This page lists the known errors on the gm5x5x5 PCBs. There are no known issues with the bulk order run (white PCBs), the following information is valid **only** for the prototype run (green PCBs).

Bulk Order #1

#1 MIDI IO pins

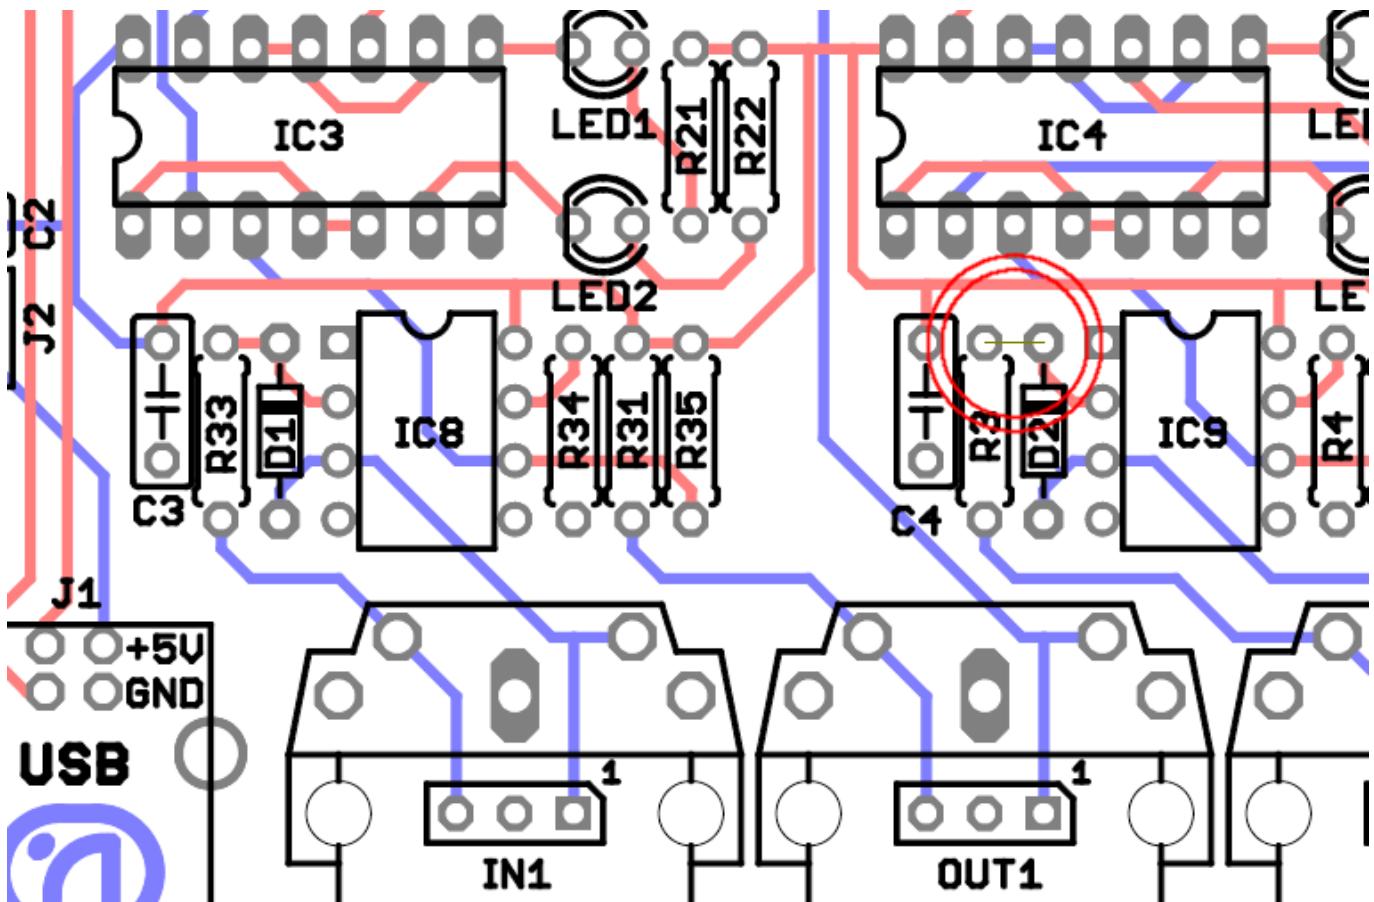
Problem: The MIDI IO pins of the midi sockets (Pin 4 + 5) are switched.

Solution: Either (1) use the pin-headers if you use sockets that are not mounted on the PCB or (2) break the traces to pins 4 + 5 of the sockets and solder wires to them or (3) solder the midi sockets on the other side of the PCB.
